4396B-14

S E R V I C E N O T E

Agilent 4396B Network/Spectrum/Impedance Analyzer

New Replaceable Parts for Probe Power Supply

Figure 1 Filter board replacement

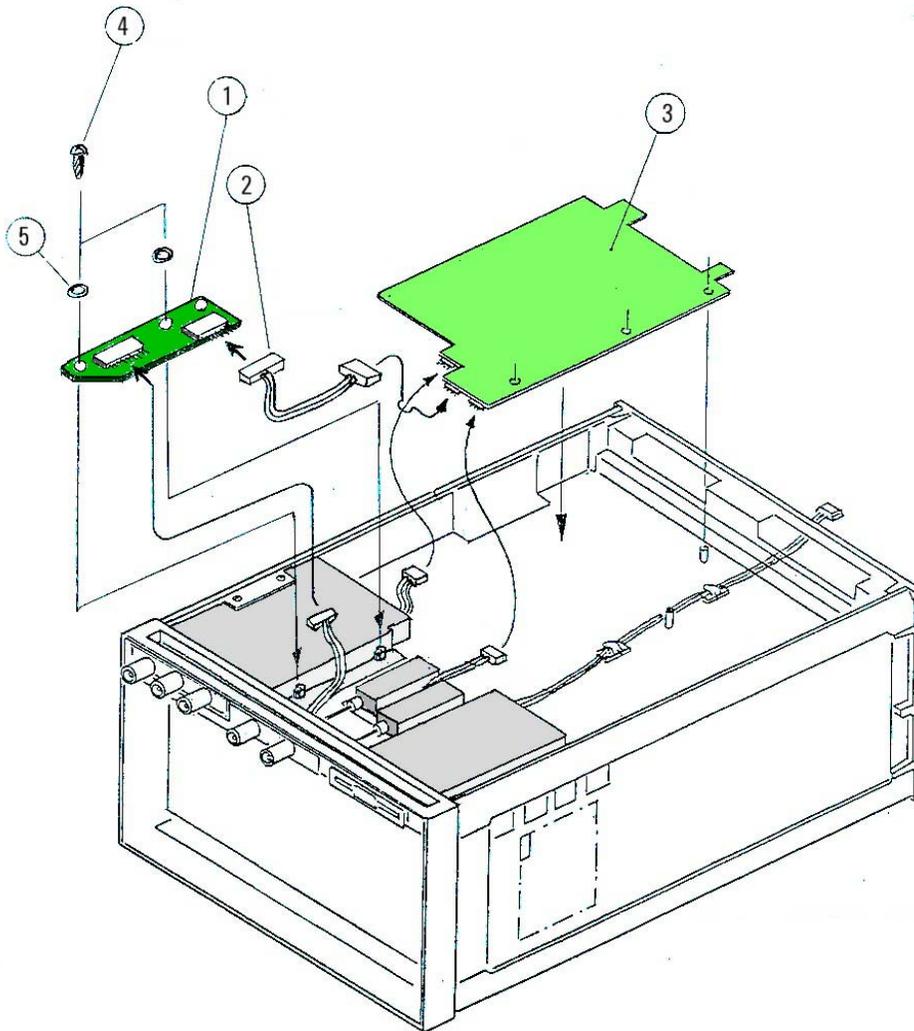
New filter board (P/N E4970-66530) and wire assembly (P/N E4970-61685) were added to the probe power line of the 4396B in order to improve the isolation between the RF circuits and probe power cable. The allocation of replaceable parts for the probe power line was changed.

When replacing the new parts of the probe power line, order appropriate parts referring to the following parts list.
